REMARKS

Drawings

Fig. 2

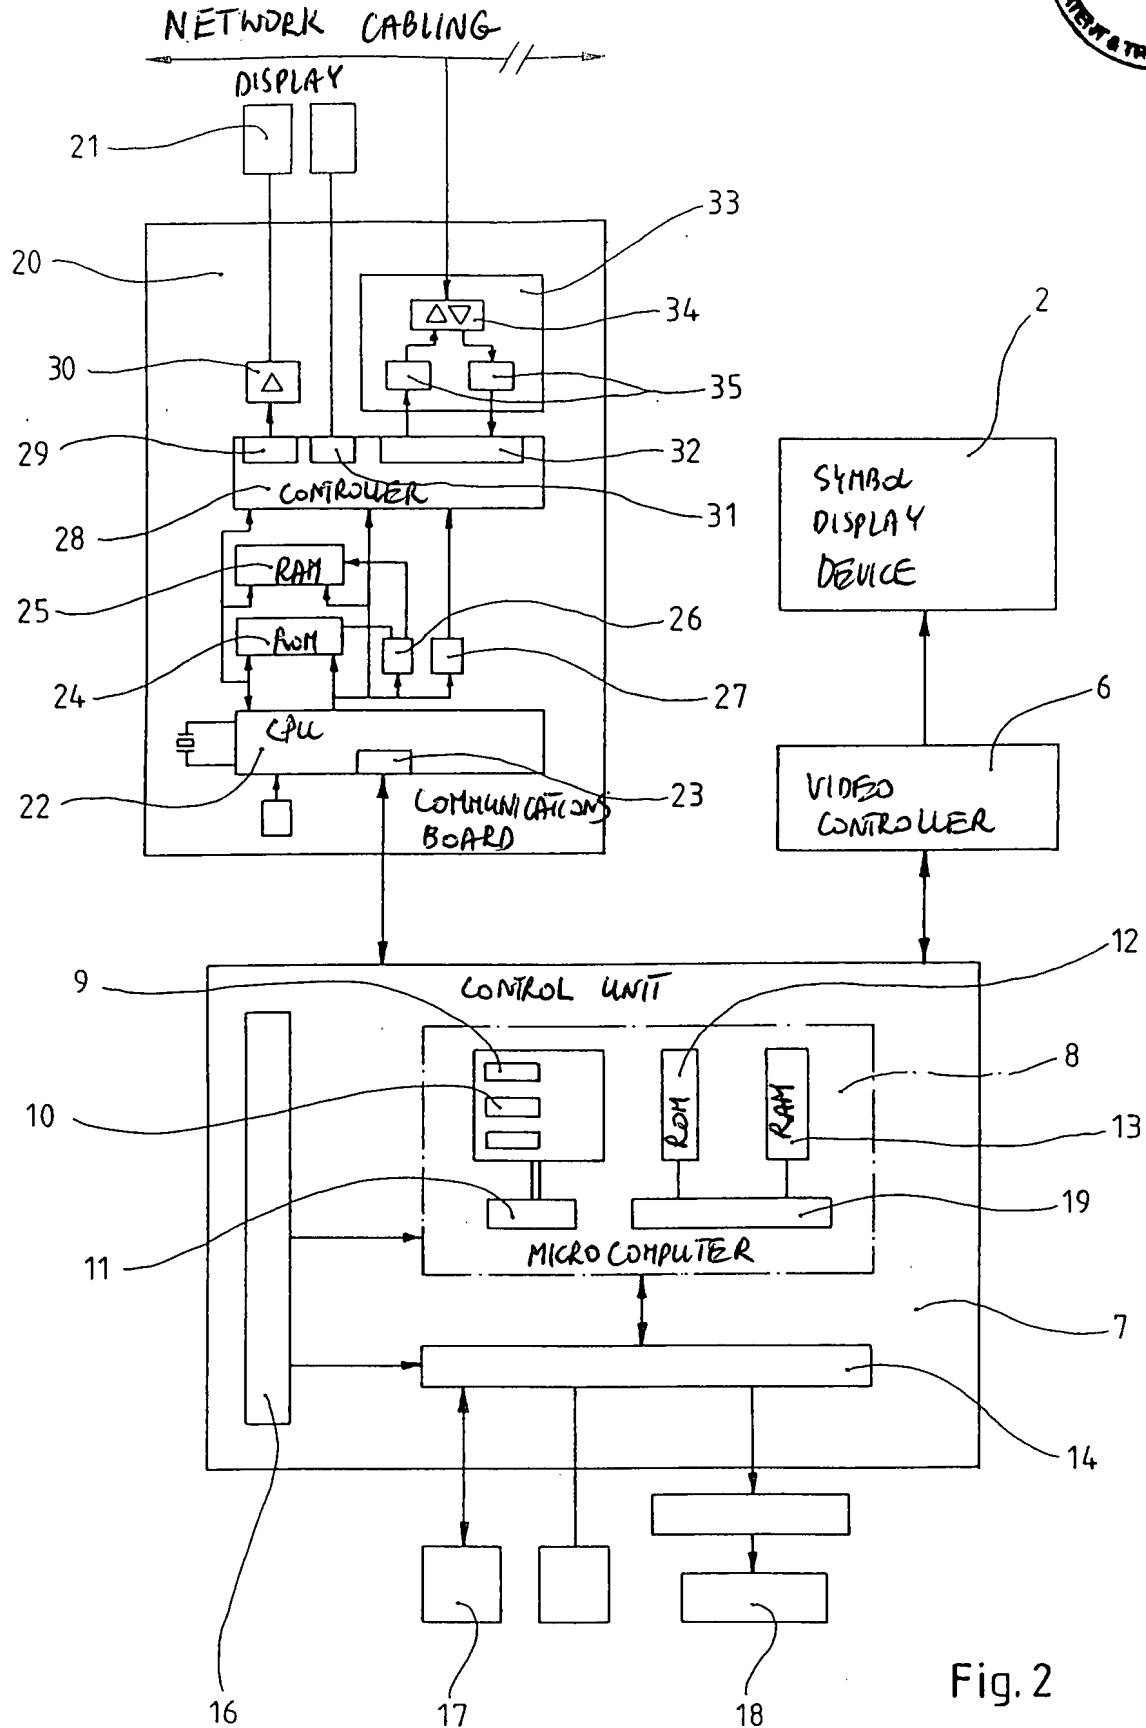
The Office Action of July 13, 2007 states that the drawings are objected to as failing to comply with 37 CFR 1.84(p)(5) because they include the following reference character(s) not mentioned in the description: Reference characters 14,16,17,18,19 and 23 are shown in Fig. 2 but not mentioned in the specification. Corrected drawing sheets in compliance with 37 CFR 1.121(d), or amendment to the specification to add the reference character(s) in the description in compliance with 37 CFR 1.121(b) are required in reply to the Office action to avoid abandonment of the application. Any amended replacement drawing sheet should include all of the figures appearing on the immediate prior version of the sheet, even if only one figure is being amended. Each drawing sheet submitted after the filing date of an application must be labeled in the top margin as either "Replacement Sheet" or "New Sheet" pursuant to 37 CFR 1.121(d). If the changes are not accepted by the examiner, the applicant will be notified and informed of any required corrective action in the next Office action. The objection to the drawings will not be held in abeyance.

Additionally, the drawings are objected to because Fig. 2 is merely a set of boxes with numbers. Components should be labeled in such a manner that those reading the drawing can determine the basic components of the system. Corrected drawing sheets in compliance with 37 CFR 1.121(d) are required in reply to the Office action to avoid abandonment of the application. Any amended replacement drawing sheet should include all of the figures appearing on the immediate prior version of the sheet, even if only one figure is being amended. The figure or figure number of an amended drawing should not be labeled as "amended." If a drawing figure is to be canceled, the appropriate figure must be removed from the replacement sheet, and where necessary, the remaining figures must be renumbered and appropriate changes made to the brief description of the several views of the drawings for consistency. Additional replacement sheets may be necessary to show the renumbering of the remaining figures. Each drawing sheet submitted after the filing date of an application must be labeled in the top margin as either "Replacement Sheet" or "New Sheet" pursuant to 37 CFR 1.121(d). If the changes are not accepted by the examiner, the applicant will be notified and informed of any required corrective action in the next Office action. The objection to the drawings will not be held in abeyance.

Applicant amends the specification of the present application in order to incorporate the missing reference characters.

Applicant submits the Replacement Sheet which provides description of the basic components of the system presented in Fig. 2. Applicant also encloses the Annotated Sheet showing the changes in Fig. 2 in red color.
